AE540 N "economy" version
Modification for use of DTMF Mic

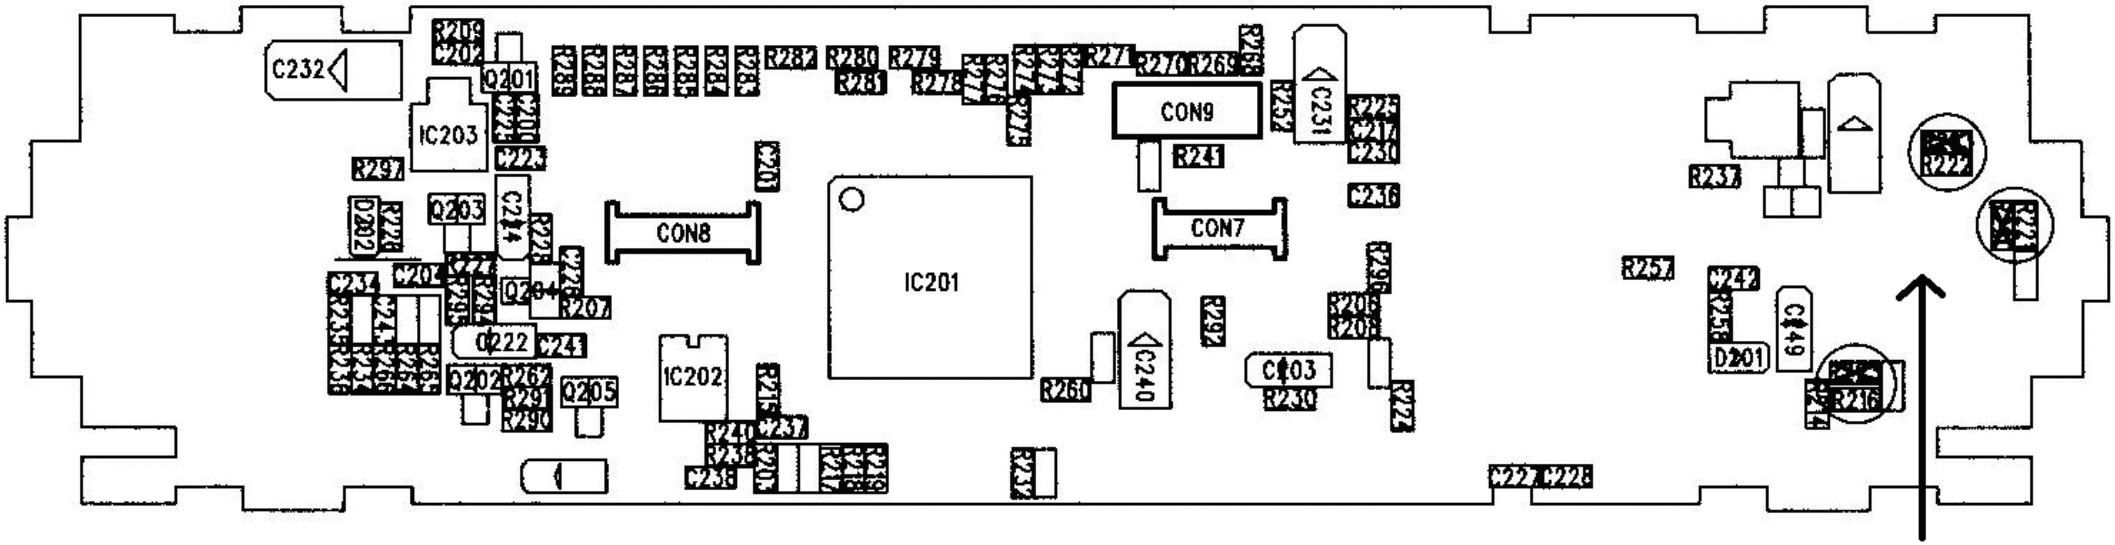
R293 Delete
R222 ADD

R220 Delete
R221 ADD

R223 Delete
R216 ADD

all resistors = 0 Ohms
only shifting to new
position necessary
